Project Name: Greensprings Plantation Resort PH 1 Timeshares  
 County Plan No.: SP-13-94  
 Stormwater Management Facility: LAKE A WET POND

GREENSPRINGS PLANTATION  
RESORT PHASE I

PHASE I MASTER STORMWATER PLAN  
 GREENSPRINGS: PLANTATION RESORT PHASE I  
 JAMES CITY COUNTY, VIRGINIA

CODE COMPLIANCE REVIEW COMMENTS  
GREENSPRINGS PLANTATION, PHASE 1  
PLAN NO. SP-13-94 DEC  
February 17, 1994

# AM PROFILE A-A'

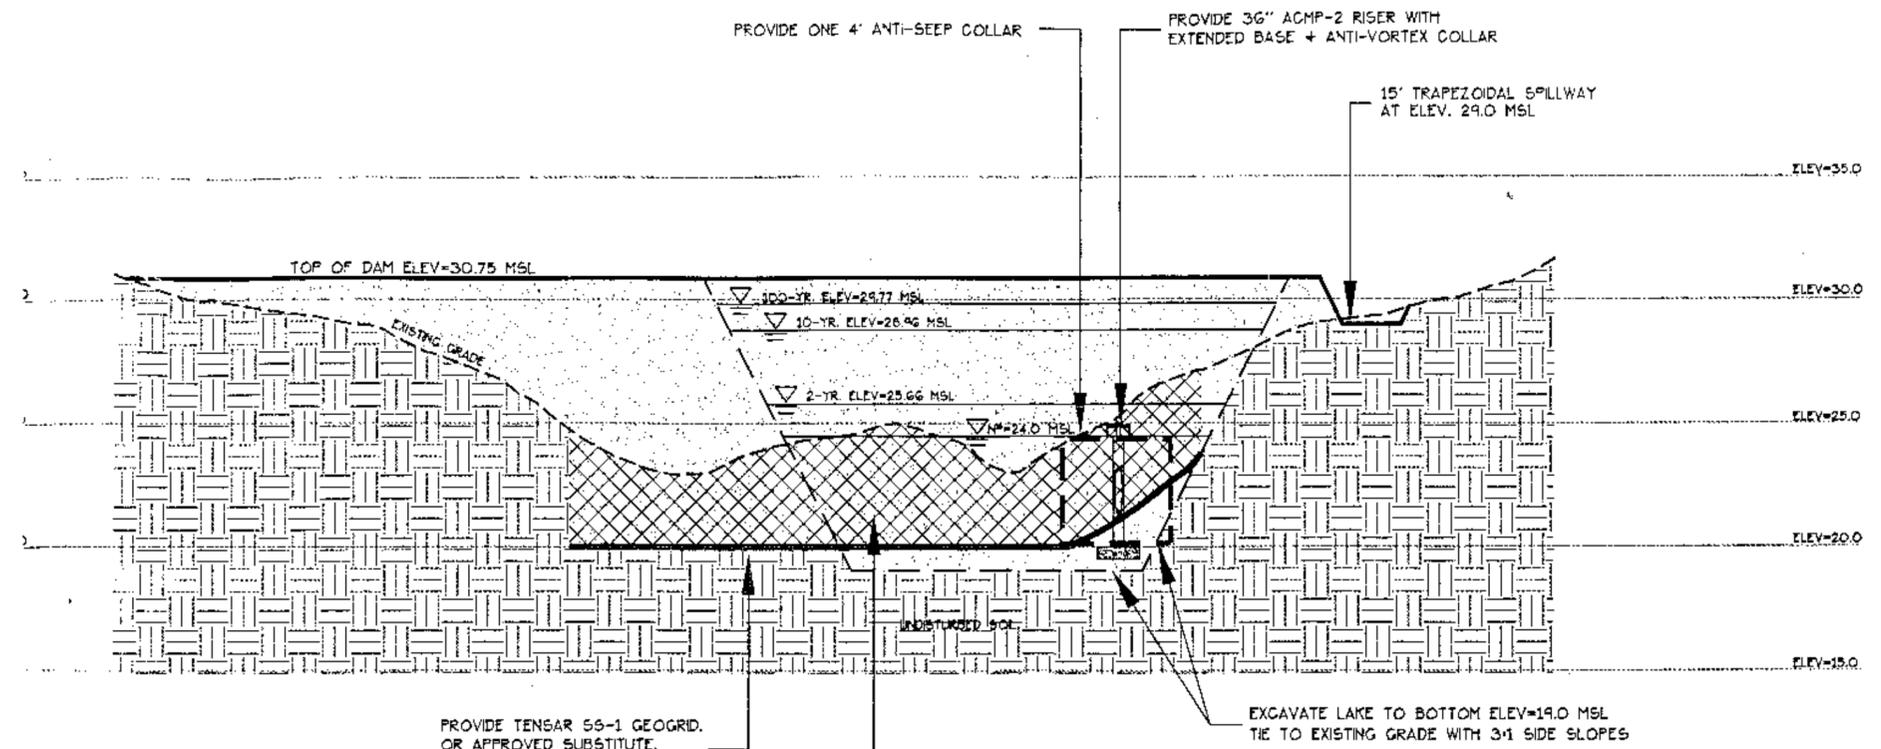
*HOPE SUBSTITUTE? SEE LETTER.*

John wants to substitute this ADS N-12 for the ACMP Barrel in Lake A (timeshares). He plans to use a precast Riser + Conti Vortex.

PROVIDE ONE 4' ANTI-SEEP COLLAR

PROVIDE 36" ACMP-2 RISER WITH EXTENDED BASE + ANTI-VORTEX COLLAR

**DESIGN OUTLET PROTECTION  
 FOR CULVERT AT STA. 5+10**

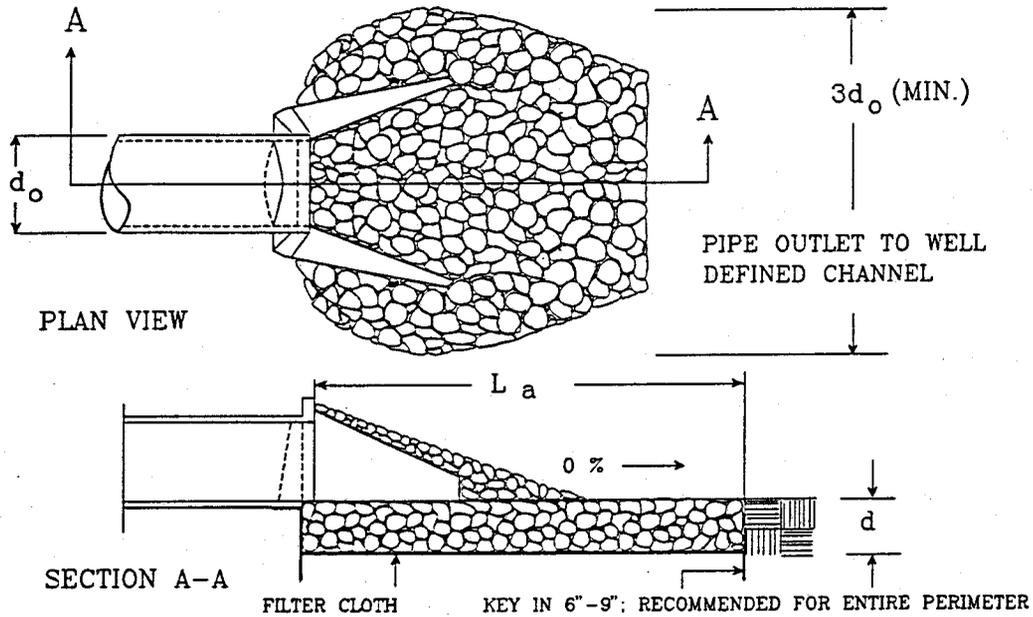
5. There are two No. 3 drainage inlets. Relabel one of these to be No. 2.
6. Provide riprap outlet protection for all pipe systems and culverts. Specify the amount of stone to be used in accordance with Specification

3.19 of the third edition of the Virginia Erosion Control Handbook (VESCH). *Already on plans*
